**TOWN OF HERNDON, VIRGINIA
ARCHITECTURAL REVIEW BOARD
WORK SESSION AGENDA
NOVEMBER 6, 2019
HERNDON MUNICIPAL CENTER
2nd floor, LARGE CONFERENCE ROOM
777 LYNN STREET
7:30 P.M.**

Case Number & Type: ARB #19-38; New construction
Case Summary: Construction of a new multi-story hotel building housing two new hotel brands.
Case Location: 232 Sunset Park Drive, Sunset Business Park

HILTON GARDEN INN & HOME 2 - HERNDON, VA

NORTHWEST ELEVATION

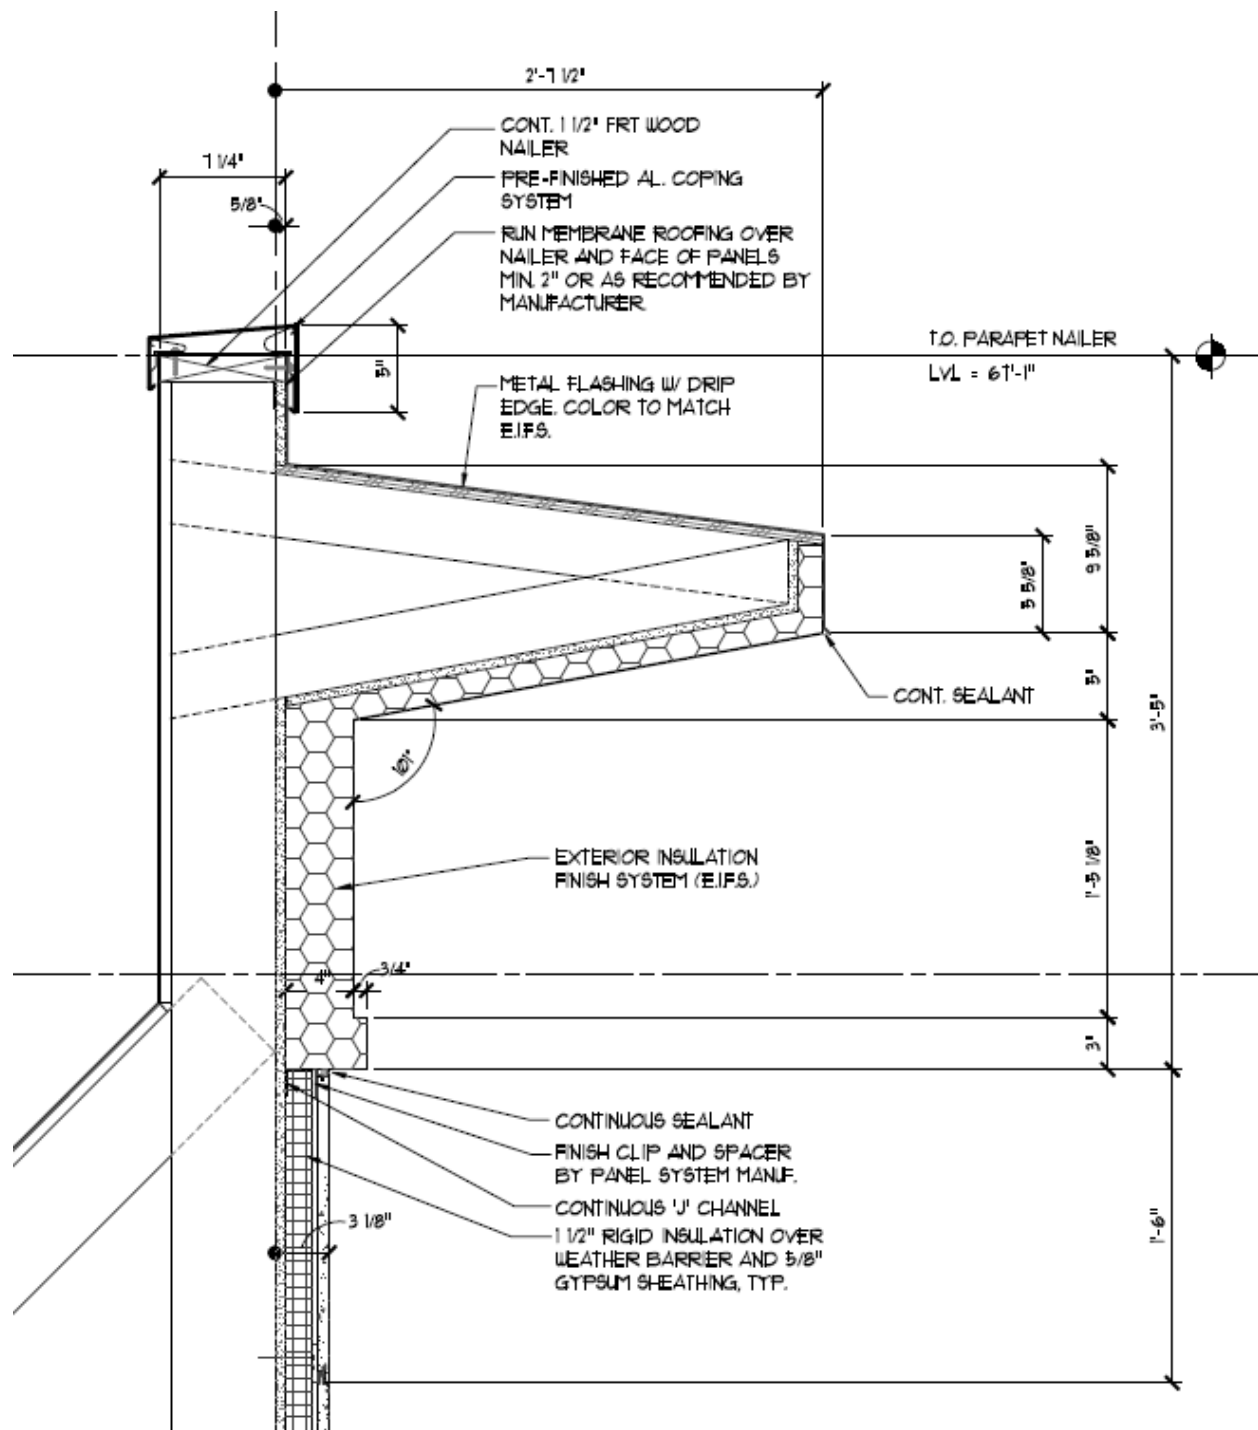
Staff finds the 12-division and 16-division storefront windows on the northwest façade to be awkwardly contrasting to the windows on the rest of the building. Staff recommends discussing a selection with fewer divisions on the first floor of this elevation for a more cohesive design.

- a. Porte-cochere structure on the northwest elevation;
- b. Dimensions/orientation of the gray accent Nichiha® fiber cement board panels;
- c. Guest room window section / grill design;
- d. Glazing and/or window glass color or tints, if any;
- e. Exterior lighting to be placed on the building or on the site; and
- f. Any site features, such as site furnishings or fencing.
